**City of Charlottesville  
Board of Architectural Review  
Staff Report  
January 21, 2026**

**Pre-application discussion: CoA in HC District**  
BAR # HST25-0119  
705 St. Charles Ave, TMP 520155001  
Martha Jefferson Historic Conservation District  
Owner: Kimberly and Galen Suppes  
Applicant: Marcelino Arroyo / Nola Builds  
Project: New residence on vacant parcel

- Submittal: BNC Homes of Virginia drawings for *NEW HOME: Pro 5 MODEL, ST. Charles Ave.*, dated October 3, 2025, 24 pages. (Attached to this staff report are excerpts showing the front and side elevations.)

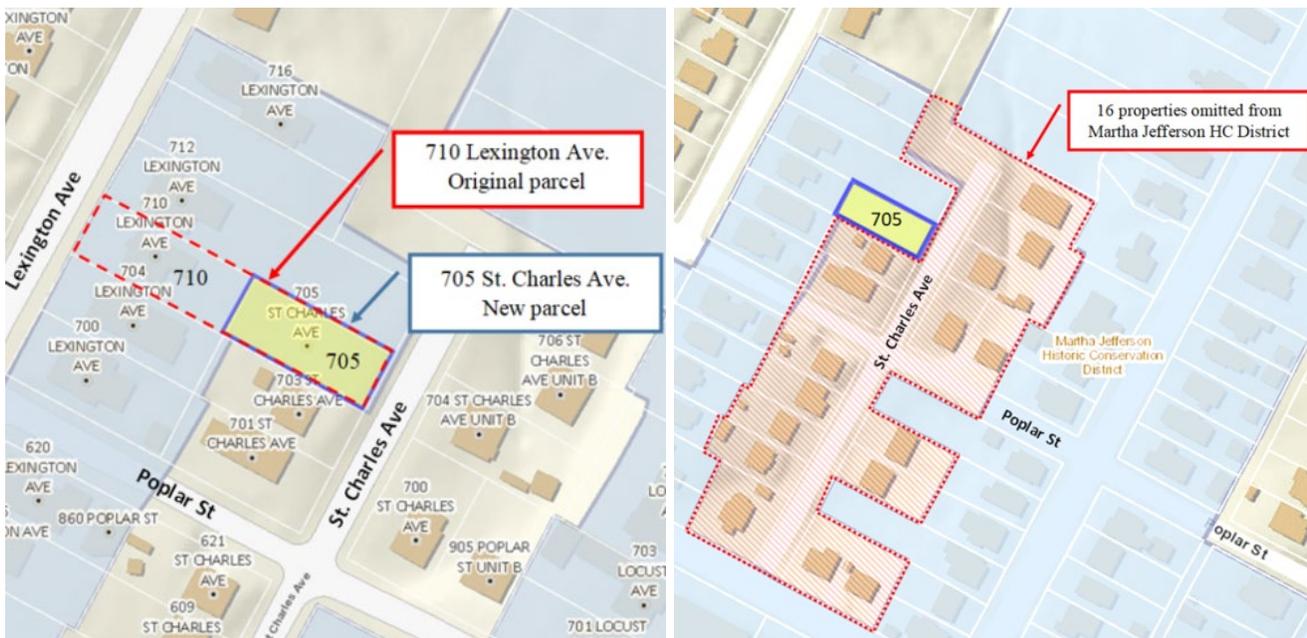
For the proposed dwelling at 705 St. Charles Avenue, the garage is integral to the house, accessible from the street with doors on the front elevation. However, this conflicts with the zoning for this district, which requires garages be at least 10-feet behind the primary façade and no wider than 40% of the primary façade. Resolution may alter the design; however, staff’s primary questions (below) are related to the design in-concept and materiality.

1. **Is the design appropriate?** The architecture is neither traditional nor contemporary, borrowing elements from various styles. The siding, shakes, eave brackets, porch columns, window lite patterns, and stone foundation suggest a Craftsman-style design intent. Conflicting with this intent are elements such as the shallow eaves, the three, dissimilar dormer types of the front elevation, the prevalence of vinyl and PVC materials, and the expansive side elevations with limited and dissimilar windows.

This dwelling fronts on a street not within the district and is immediately adjacent to no designated structures. To what extent should it be *visually and architecturally compatible* with the surrounding district? If the intended Craftsman-style is compatible, does the overall design, as presented, achieve that intent? consistent with and appropriate for that intent?

2. **Is the materiality appropriate?** Per the guidelines, *materials and textures should relate architecturally to the district and be compatible with and complementary to neighboring buildings; that long-lasting, durable and natural materials are preferred.* Throughout the Martha Jefferson HC district, dwellings with horizontal siding are common, and several feature decorative shingles on gables. However, there are few examples of vinyl and PVC elements, and there are no examples where their use is so prevalent.

Unlike ADC Districts, the HC District guidelines do not specifically recommend against the use of synthetic materials, including vinyl. Is the use of vinyl and PVC materials consistent with the design guidelines for this district?

**Staff Comment:** On the primary façade, window and door alignments and patterns are compatible with the district.

**Staff Comment:** [See question in *Discussion.*] Throughout this district, dwellings with horizontal siding are common, and several feature decorative shingles on gables. However, the prevalent use of vinyl and PVC materials is inconsistent with the preference for *long-lasting, durable and natural materials.*

**Staff Comment:** [See comments in *Discussion.*] The garage is part of the house, accessible from the street with doors at the front elevation. However, this will require modification in order to comply with the City Code. For this zoning district, garages must be positioned at least 10-feet behind the primary street facing building façade and are limited in width to no more than 40% of any street facing façade.

**Staff Comment:** [See question in *Discussion.*] The architecture is neither traditional nor contemporary, borrowing elements from various styles. The siding, shakes, eave brackets, porch columns, window lite patterns, and stone foundation suggest a Craftsman-style design intent. Conflicting with this intent are elements such as the shallow eaves, the three, dissimilar dormer types of the front elevation, the prevalence of vinyl and PVC materials, and the expansive side elevations with limited and dissimilar windows.

BUILDING PERMIT PLAN FOR  
TAX MAP 52, PARCEL 155

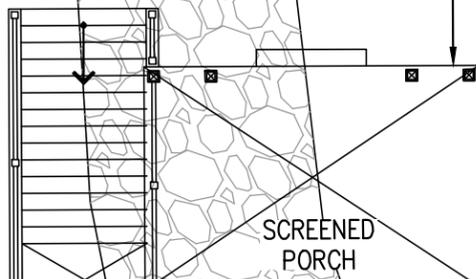
**Staff Comment:** Spacing between the new dwelling and that on the adjacent parcel (703 St. Charles) is approximately 12-feet. Spacings for the nearby structures range between 10 and 30 feet.

**Staff Comment:** The site's grade rises from front to back. The first floor is one-half story above grade, with stairs to the porch entry. An elevated front entrance is not unusual for this district.

**Staff Comment:** There are no existing large trees on the site. To meet zoning requirements, a 10% tree canopy will be required.
